Removal of existing shed and replacement with new shed (in retrospect)
At 16 Western Gardens Edinburgh EH12 5QD

Application No: 20/05305/FUL

Report of Handling

Neighbour Response to LRB application 21/00043/REVREF

Picture of old shed.

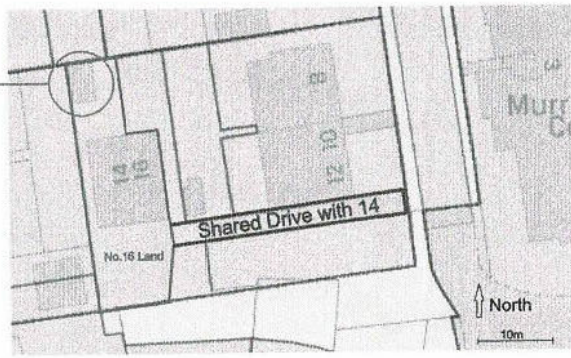
The Title sheet shows the shed in 16 Western Gardens was definitely not the same width or height of the replacement one. I have attached a picture of the old shed where you can see that it is definitely not of the same dimensions and is in fact a lot smaller than the new shed.

Site plan submitted with original planning application.

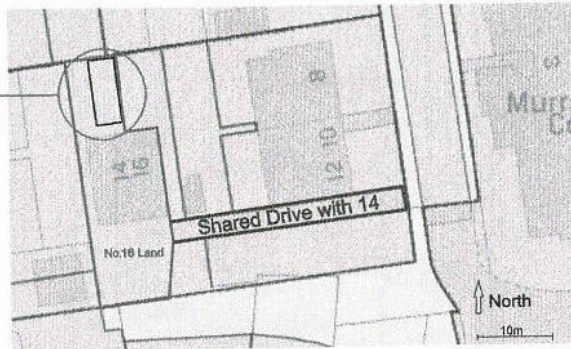
As you can see from the site plan layout Mr Cruickshank submitted with the original application the new shed takes up twice as much space as the previous shed did.

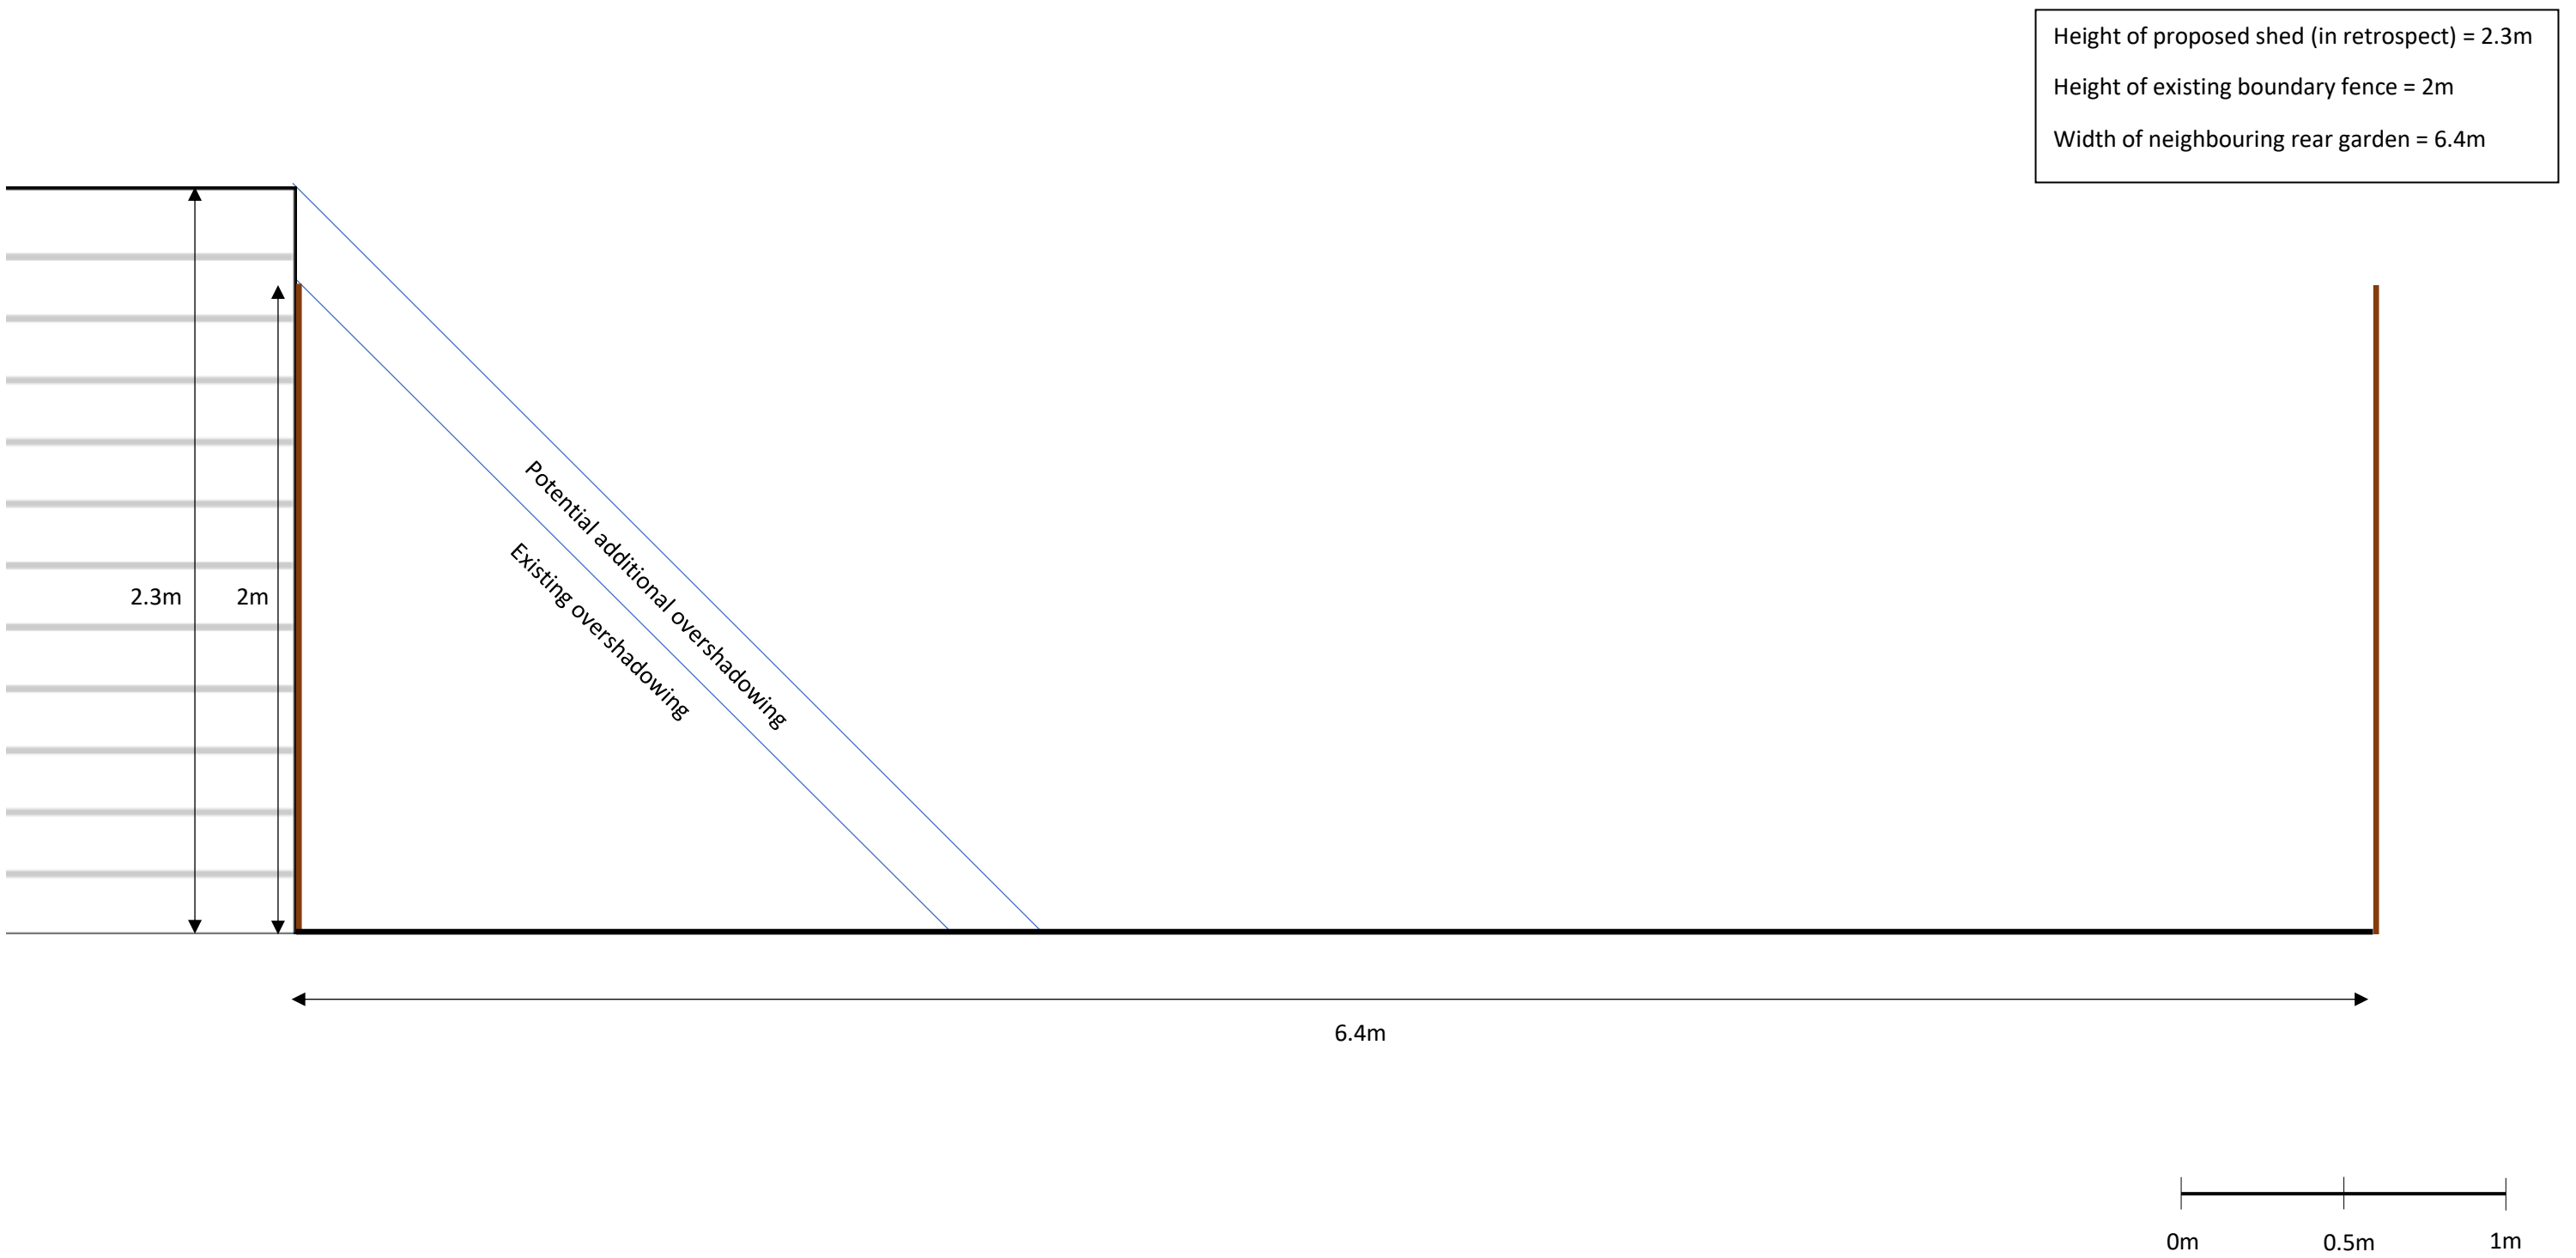
In this case, the proposal was judged to be south west of the neighbouring garden. The calculator finds that, with this orientation, the proposal would result in approximately 2.977 sq.metres of potential adverse overshadowing.

As such, it was considered that as the maximum area of adverse overshadowing from the proposed shed would be approximately 2.977 sq.metres on a garden with an area of approximately 67.5 sq.metres, any impact would be limited (direct quote above). Any additional overshadowing would be ‘visible’ as a thin additional strip that would run the length of the shed (approximately 9 metres), on top of any existing overshadowing resulting from the existing boundary fence.

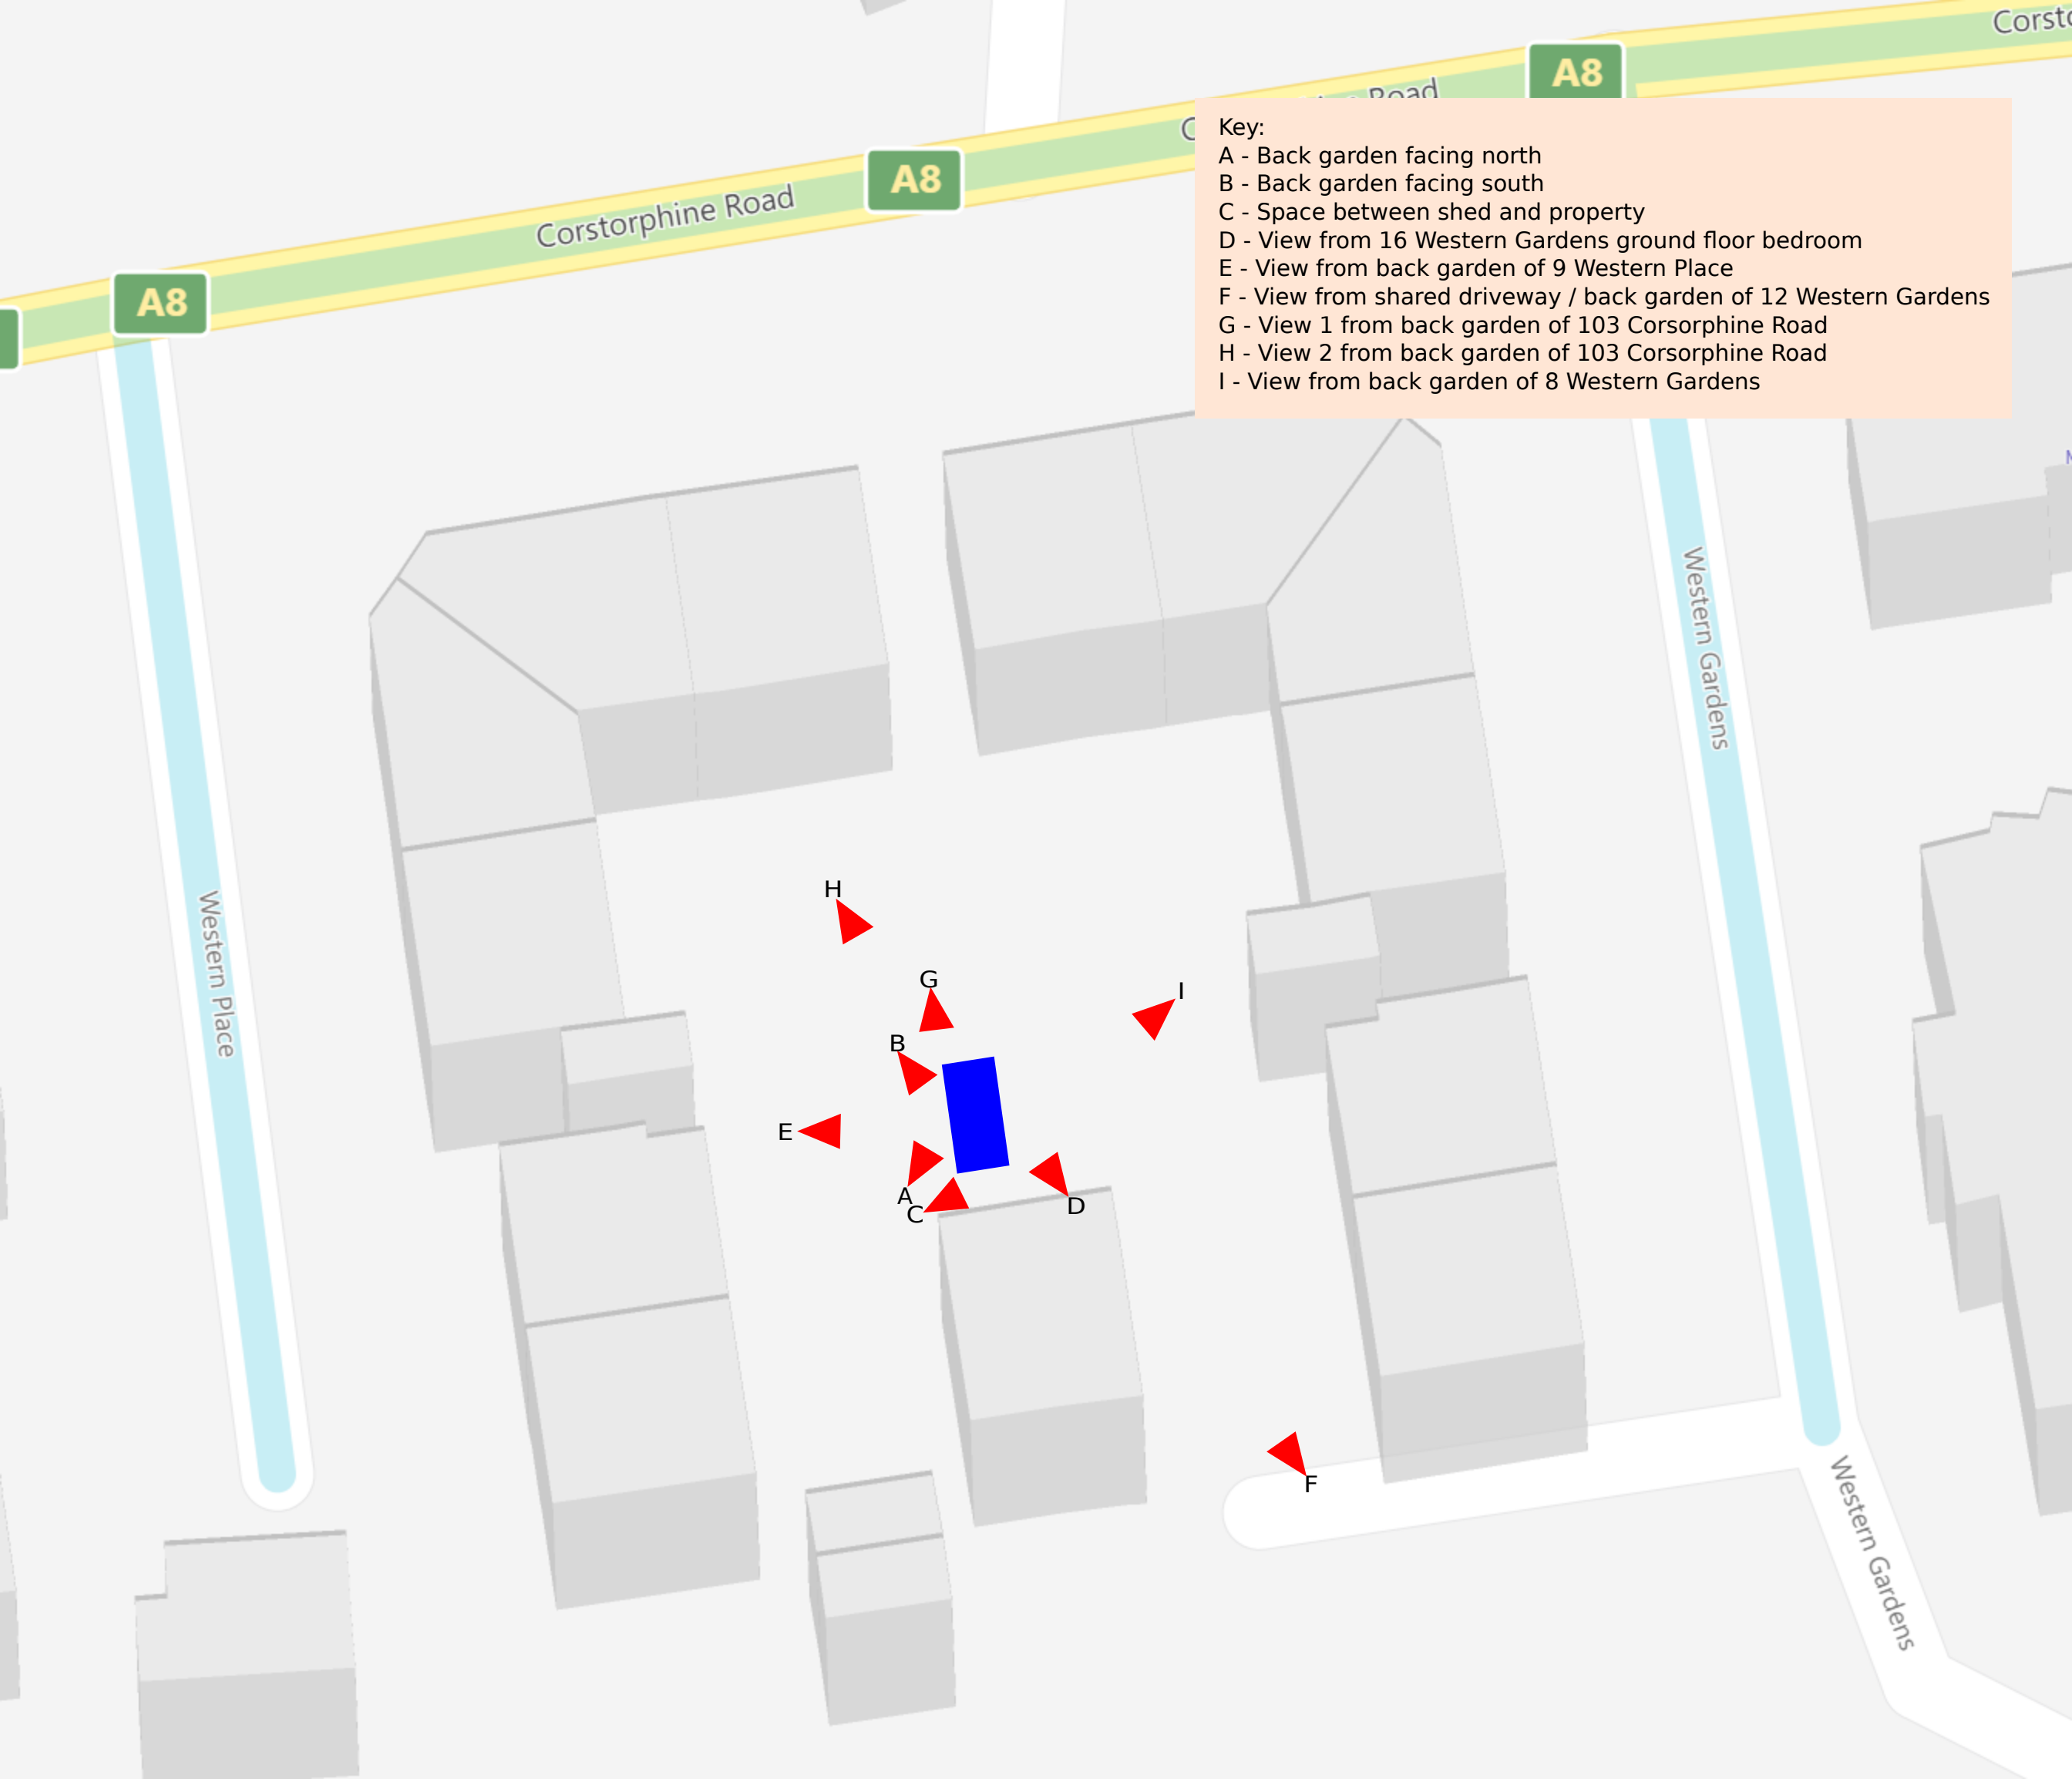
If the shed is judged to be directly to the west of the neighbouring garden, then the calculator suggests there would be no area of adverse overshadowing (0 sq.metres).

Picture of old shed.

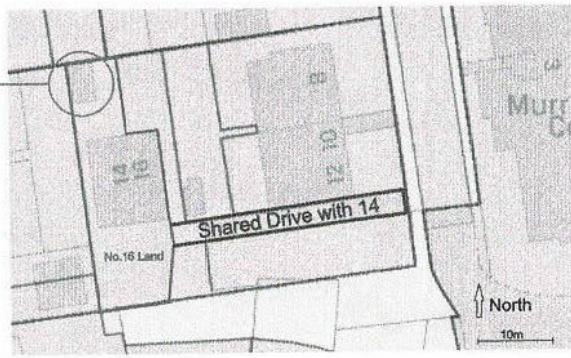
The Title sheet shows the shed in 16 Western Gardens was definitely not the same width or height of the replacement one. I have attached a picture of the old shed where you can see that it is definitely not of the same dimensions and is in fact a lot smaller than the new shed.

Site plan submitted with original planning application.

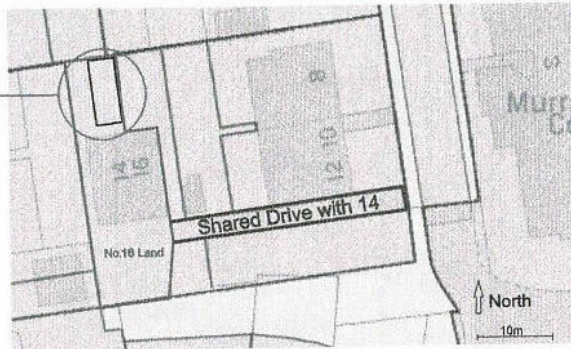
As you can see from the site plan layout Mr Cruickshank submitted with the original application the new shed takes up twice as much space as the previous shed did.
